**PORT of  
TOWNSVILLE**

Report for Townsville Marine  
Precinct Project EIS  
Supplementary Information  
Report

January 2010

**Figure 2-1 Water level (m) under flood scenario for the Developed (D, black line) and Existing (E, red line) conditions at Ross River mouth/entrance (top panel), proposed marina site (middle panel) and breakwater entrance/channel (bottom panel).**

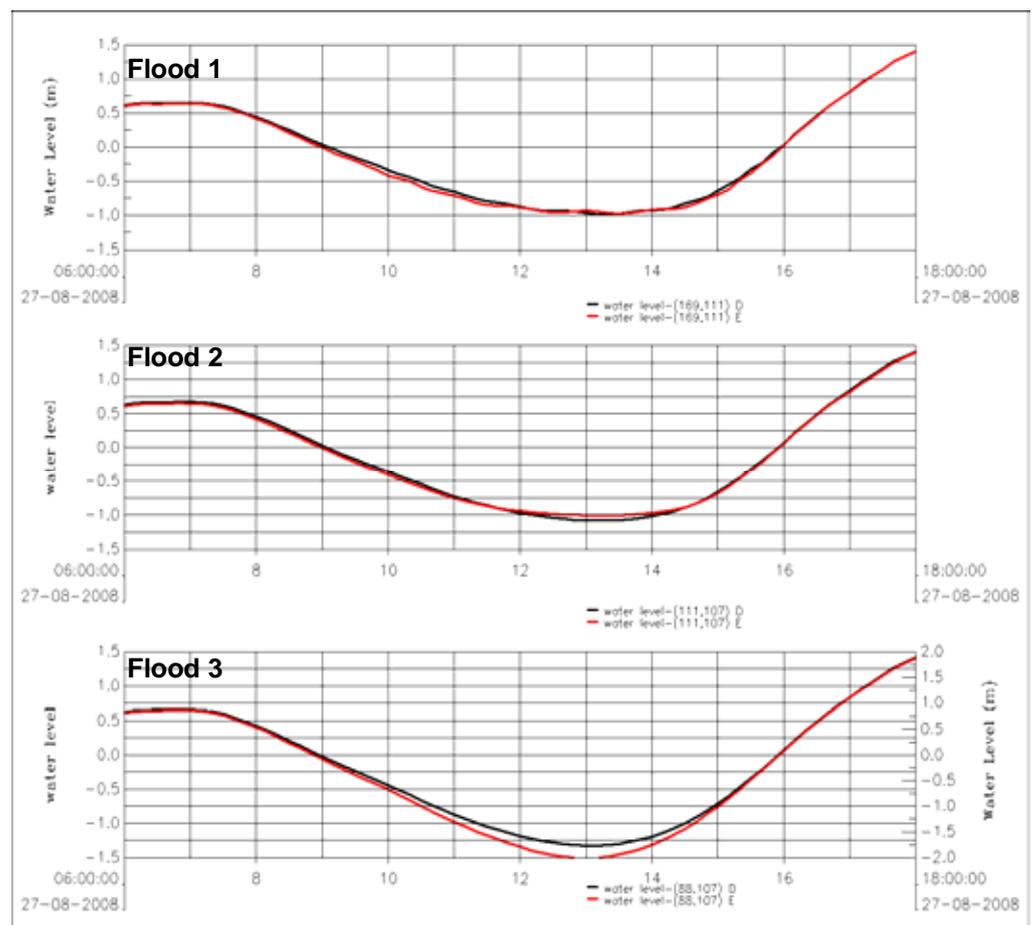
Submissions 5, 318, 327 and 328 raised concerns regarding flooding issues associated with the narrowing of the mouth of the Ross River from construction of the new bridge and reclamation of lands to build the TMPP. Queries regarding hydrodynamic modelling were raised with concern that a 1 in 1 year storm event without a 100 year Average Return Interval (ARI) had been used as basis for flooding assessment for the TMPP. It was suggested that cumulative impacts of a 1 in 100 year ARI event coinciding with storm tide conditions should be considered.

Figure 2-1 provides predicted water levels as a result of the proposed development at three locations based on modelling that included the Precinct footprint and the TPAR. Given that the TPAR is expected to be in place by the time of Precinct construction it was important to understand if the Precinct would result in any afflux potential under this developed scenario.

The top panel in the figure represents conditions at the mouth of the Ross River from data extracted from a mid channel position under the proposed TPAR. This model output indicates no difference in water level between the existing and developed scenarios. This shows there are no upstream affects on afflux predicted from the construction of the Precinct within the Ross River. Adjacent to the proposed Marina site (refer middle panel of Figure 2-1) only small increases (0.10 m) are seen. Larger differences are observed in the region between the Precinct and the breakwater, with water level elevation differences of up to 0.25 m indicated adjacent to the breakwater entrance, though it is important to note that these occur at low tide, and hence do not affect the peak flood level. However, even though differences are seen downstream of the Precinct, the top panel in the figure demonstrates that these downstream affects do not result in any upstream affects.

Figure 2-2 Existing (left) and Developed sediment deposition measurements following flood events in Ross River.

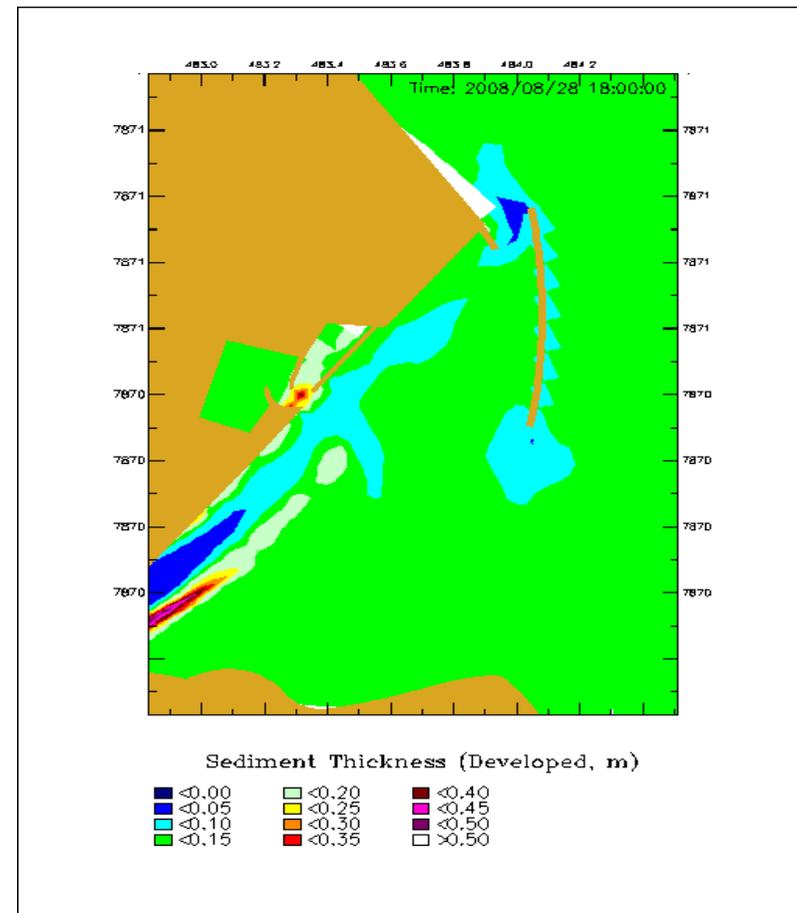
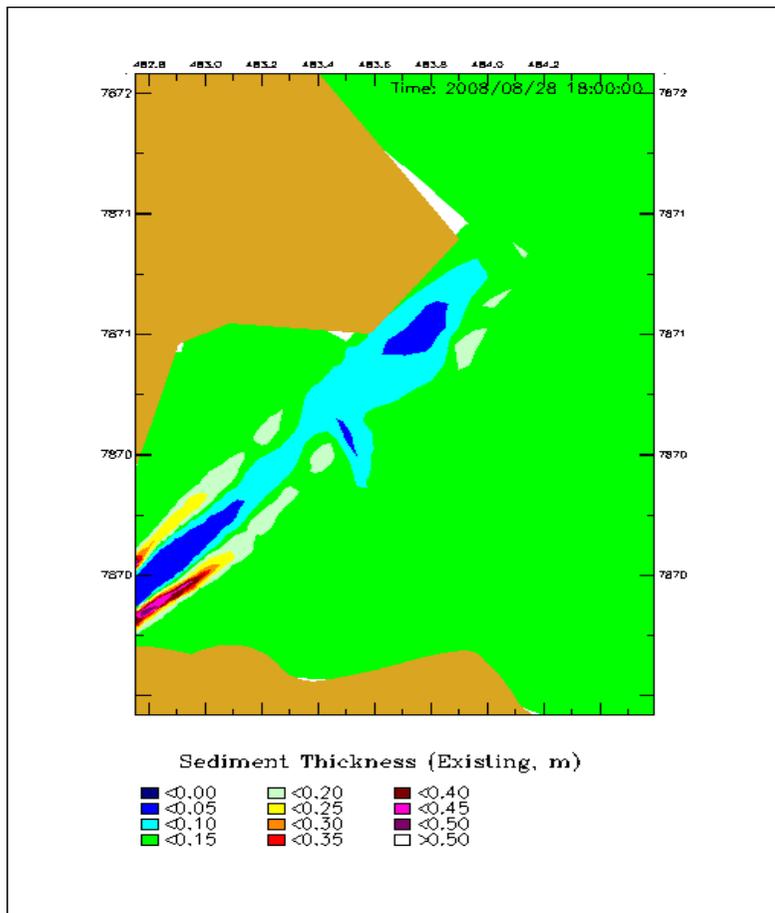
Under this scenario of fine sediments moving down Ross River into Cleveland Bay and potentially redepositing onto The Strand there is concern that if Lot 773 is reclaimed the fine sediment that might otherwise be trapped on Lot 773 would remain in suspension in the water column and would contribute to the sediments that may become available for resuspension and deposition onto the beaches of The Strand on windy days. This would result in an indirect impact of muddying The Strand.

The modelled outputs indicate that currently sediment deposition of the order of 0.15 m occurs across the footprint of the Precinct (Figure 2-2). Comparison with the developed case scenario indicates there is little difference with similar potential for deposition on the banks of the Ross River and for slight scouring at the tail end of the eastern breakwater and in the channel between the breakwaters. Indication of sediment deposition at the mouth of the marina is also evident.

Given the findings of the sediment monitoring program and the flood model outputs Lot 773 is not considered, in its current state, to be a significant sink for fine sediments. As such, it is suggested that a significant proportion of fine materials moved down Ross River during flood events are directly deposited into Cleveland Bay. It is also suggested, based on lack of settlement of fine materials during the study, that limited material is sourced from Ross River under conditions other than flood conditions.

**Figure 2-3 Plot of Indicative Sediment Depths (m) after Two Months of Dredging in the Ross River mouth (seaward corner of current reclamation). Yellow >2 mm, dark blue <1 mm**

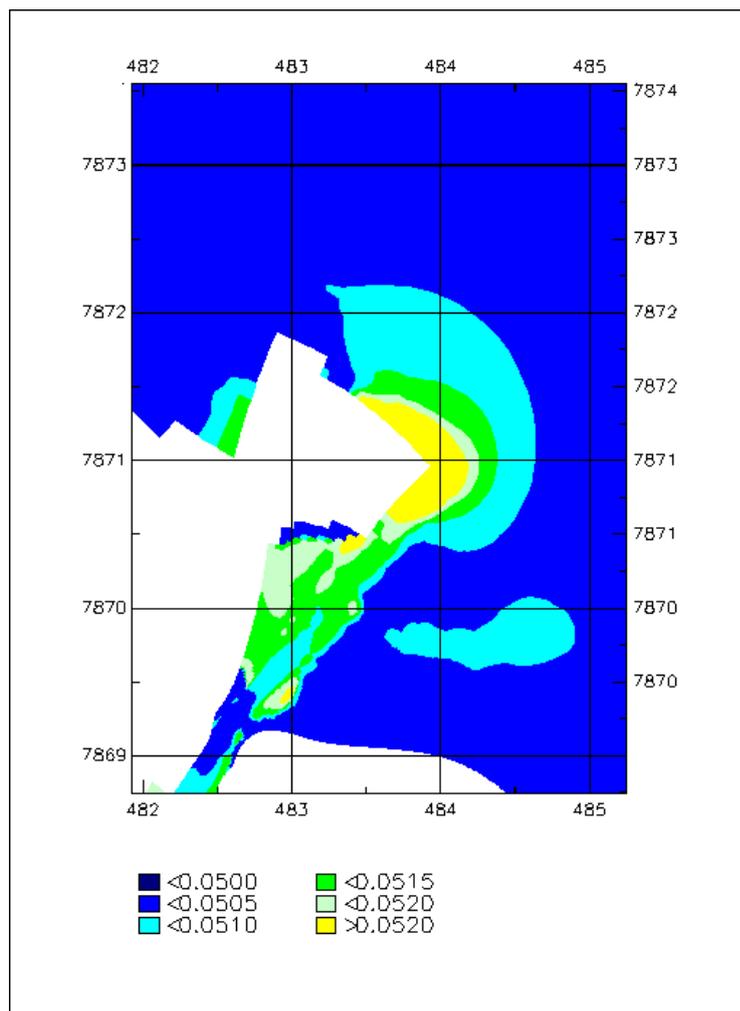
- ▶ Further information relating to alteration of sedimentation rates in adjacent habitats;
- ▶ The impacts from dredging activities releasing heavy metals and/or fine sediments on surrounding habitats and fauna;
- ▶ Reclamation of Benwell Road mudflats and the resultant inability of this area to trap muds being flushed from the Ross River;
- ▶ Increased flushing of sediment from Ross River with potential for adverse impact on Cleveland Bay and Strand beaches;
- ▶ Risk of cumulative impact on seagrass meadows from dredging operations and construction activities (acid sulfate soils), depending on wind and wave conditions;
- ▶ Treatment of dredge material for acid sulfate soil potential; and

Based on the dredging plant to be used and the approach of direct reclamation there is reduced potential for mobilisation of sediments or contaminants into the water column and, hence, reduced potential for smothering effects to adjacent sensitive habitats. This has been demonstrated by modelling undertaken for the Project, which indicates that when the dredge is positioned in the mouth of Ross River, sedimentation should not exceed ~1mm at the deepwater seagrass bed located offshore of the Ross River mouth over two months of dredging (Figure 2-3).
